BULLETIN.020

WELDMATIC 205S: CP102
CP102-11/02 TRIAC CONTROL PCB

CPI02-11/02 PCB

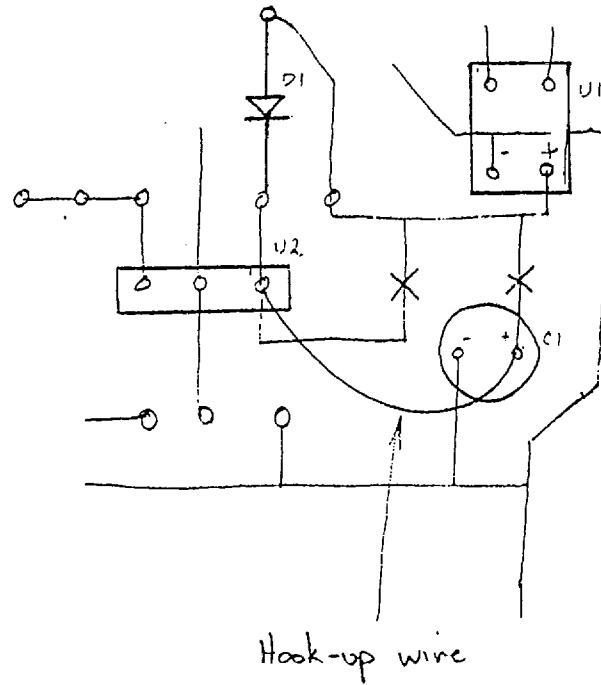
Due to faulty artwork in early production PCB's, diode D1 was effectively shorted by an unwanted section of track. Modifications were done to the boards to enable them to be used in some early production runs.

Fault: D1 diode shorted
by tracks

On the rear of the PCB, two (2) sections of track were cut and a piece of hook-up wire was used to re-route the circuit.
